STRATEGY AND POLICY COMMITTEE MEETING: 21.3.13

Architectural Centre Response to WCC Report

Richard Reid fights back – fundamental flaws in the council's flyover report

Fig 1: Views of the Carillon from Kent & Cambridge Terraces; Bottom view including Option X

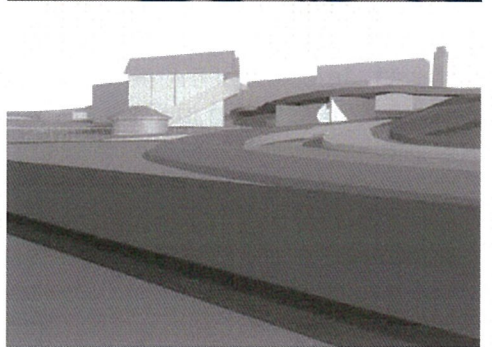
3. There appears to be a bias towards Option A. At times this is integral to the criteria (e.g. the inclusion of Option A in the Regional Land Transport Programme (p. 42) and that the flyover is currently funded through the National Land Transport Programme (p. 44) automatically rewards Option A in the Strategic Fit Analysis assessment). At other times the bias is less explicit (e.g. there is no acknowledgement that the view of the Carillon will constantly be blocked from ground level view by the undercroft of the Option A flyover (p. 56)), while the evaluation of the same criteria incorrectly claims that the Option X green bridge will block the view of the Carillon (**fig 1**).

NZTA missing predictions for traffic movement

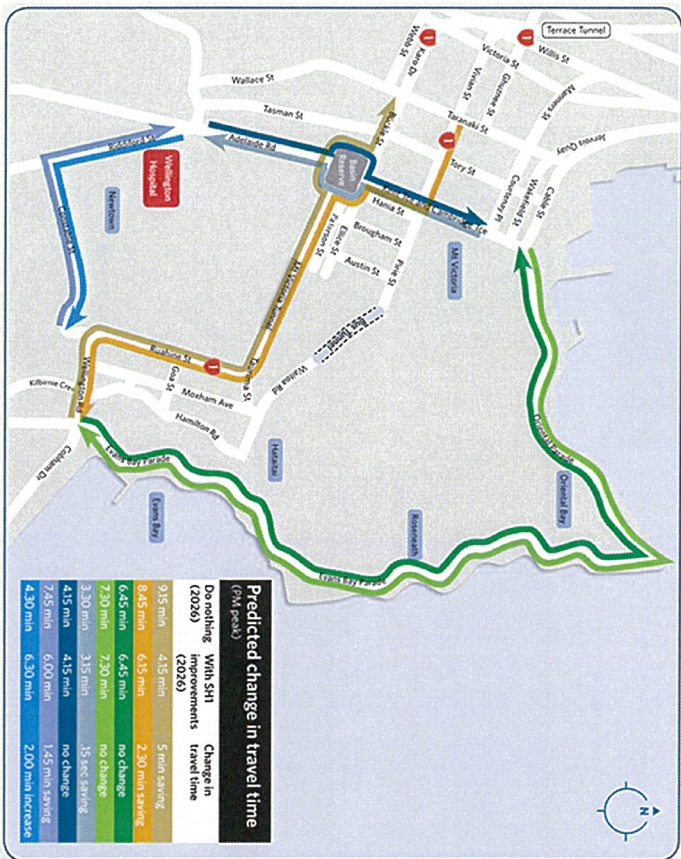
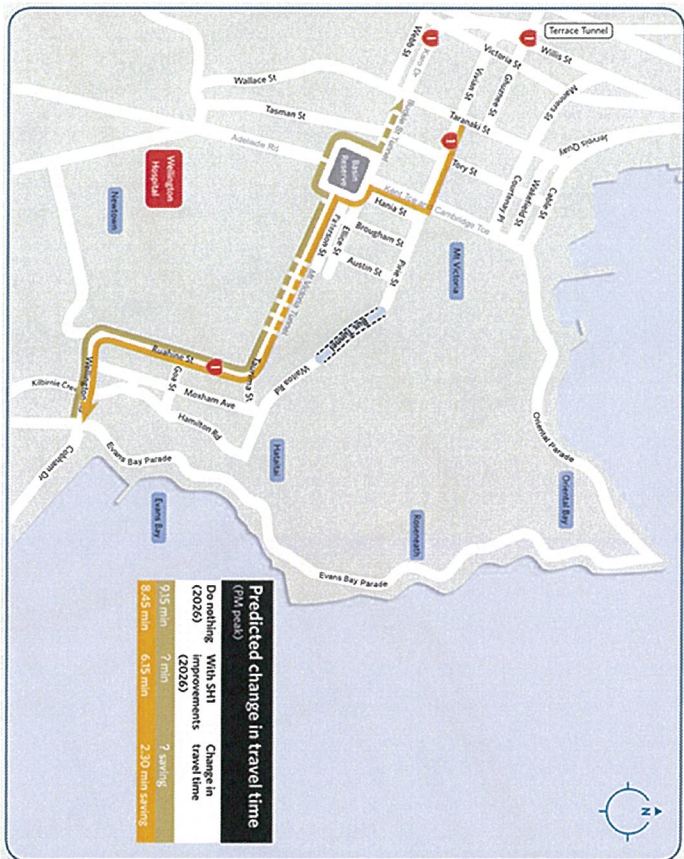
NZTA has not recognised these two key problems

What percentage of the journey/time savings will be contributed by four-laning Wellington Rd and Ruahine St, dual-laning the Mt. Victoria Tunnel, removing the lane problems at the Basin Reserve Roundabout and undergrounding Buckle St to avoid the Toy St traffic lights?
